6 December 2024

SSD-71457960 | Yorktown Parade and Fitzgerald Avenue, Maroubra - Affordable Housing Redevelopment

Appendix Q - Arboricultural Plan prepared by Arterra Design Pty Ltd - Tree Protection & Removal Plan

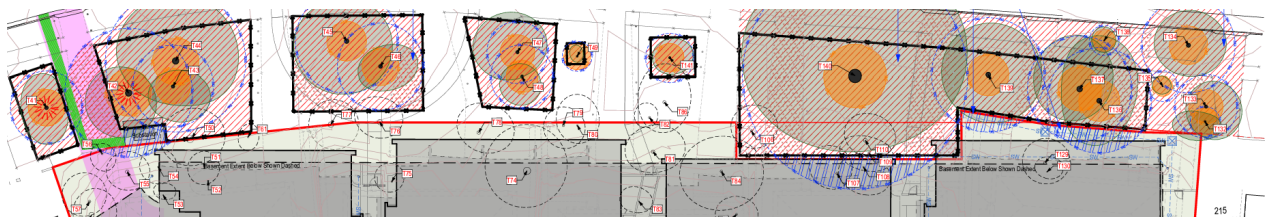
31. We appreciate that a BDAR waiver was granted by DPHI on 21 October 2024 however we refer to the numerous references to the EIS at section 7.9 which incorrectly states that the *"proposal includes the retention and protection of all trees within Fitzgerald Avenue and Yorktown Parade, and the removal of 122 trees on the Site"*. This is again reinforced throughout the EIS at section 7.5.1.
32. This appears to be an incorrect statement as evidenced by the Landscape and arboricultural plans which show that Trees 82, 86 are located outside the site boundary and are proposed to be removed.

33. There is a discrepancy between the landscape and arboricultural plans which identify that several trees are in fact not within the site boundary. Specifically tree T76 and T77 are

located on the site boundary on the arboricultural report but are located outside the site boundary in the landscape report.
